**ZONING AMENDMENT,
PLANNED UNIT DEVELOPMENT &
SUBDIVISION STAFF REPORT**

Date: April 21, 2005

University Club Apartments Subdivision

SITE PLAN

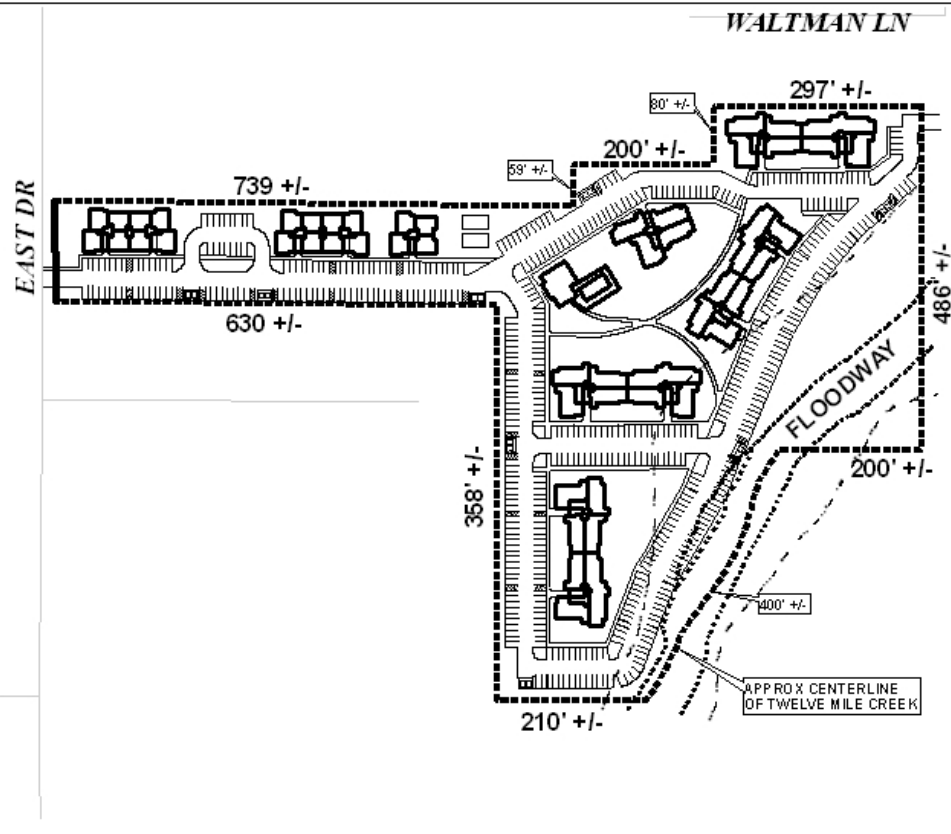
Property to be developed in compliance with state and local laws that pertain to tree preservation and protection on both city and private properties (State Act 61-929 and City Code Chapters 57 and 64). Site plan indicates several large Live Oak Trees along proposed entrance from East Drive. These trees have been labeled incorrectly and are all mature Water Oak Tree.

Regarding access the site plan illustrates access to Long Street, and the construction of Long Street to a standard approved by City Engineering should be required. Additionally, with the construction of Long Street, the provision of a sidewalk along the newly improved portion of Long Street should be required. Furthermore, as the site will be zoned R-3, full compliance with the landscaping and tree planting requirements of the Ordinance will be required.

Regarding parking, the site will consist of 168 units (552 bedrooms), and 542 spaces are provided, which exceeds the required number of spaces (252—1.5 spaces per unit). It should be noted that if the buildings are two stories in height, the PUD section of the Ordinance establishes minimum distance requirements between buildings; therefore, the spacing of the buildings must comply with Section V.C.2.b. of the Ordinance.
